Technical Service Bulletin

MODEL(S) AFFECTED: **M17 (NA S/N 000000-012000 / European S/N U00000- U00562) / T17 (NA S/N 000000-014000 / European S/N U00000- U01338)**

SUBJECT: Firmware update reduced drive wheel output to increase reliability. Drive wheel output can be increased for customers who need it increased to previous output.

Fig. 1

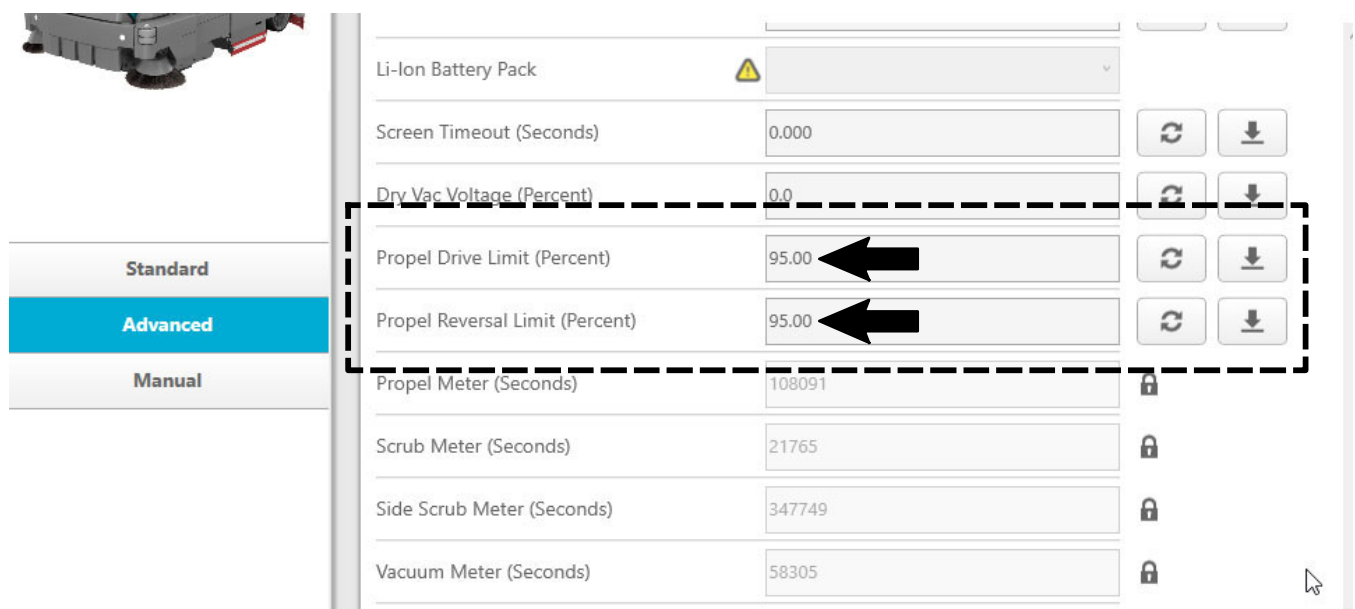
Follow instructions in *RECONFIGURING THE MACHINE AFTER NEW HARDWARE/OPTION INSTALLATION* to access Propel Drive Limit (Percent) and Propel Reversal Limit (Percent) in the Advanced configuration screen and change the output from 95.00% to 100.00%. (Fig. 1)

NOTE: The Propel Drive Limit (Percent) and Propel Reversal Limit (Percent) must be the same output. Adverse performance could occur if the Propel Drive Limit (Percent) and Propel Reversal Limit (Percent) not the same.

NOTE: Changing the drive wheel maximum allowable output from 95% to 100% could cause the drive wheel gearbox to prematurely wear.
